Intel® Server Board SE7501HG2

Specification Update

Intel Order Number: C37940-001

August, 2004

Figure 1. 38mm Fan w/1.5A requirement

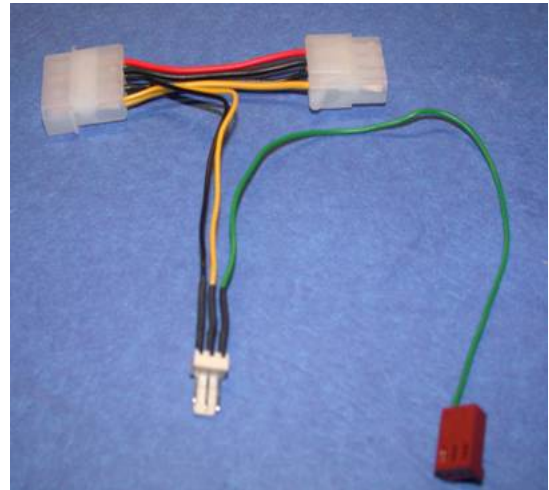
Boxed Intel Xeon® Processors at and above 3GHz use larger fans, i.e., 38mm, than the 25mm fans used in 2.8GHz and below solutions. These fans being much bigger require more current draw, i.e., 1.5A versus the 340mA required for the 25mm fan. Older SE7501HG2 baseboards (eg., PBA A95718-303) cannot support this “extra” current requirement. An easy workaround is to draw this required extra current directly from the power supply. A fan cable adapter with tachometer sense (Part #:FW04B58-DN, Supplier Foxconn, Katie.Wang@foxconn.com) solution has been proposed that accomplishes this in a rather simple fashion.
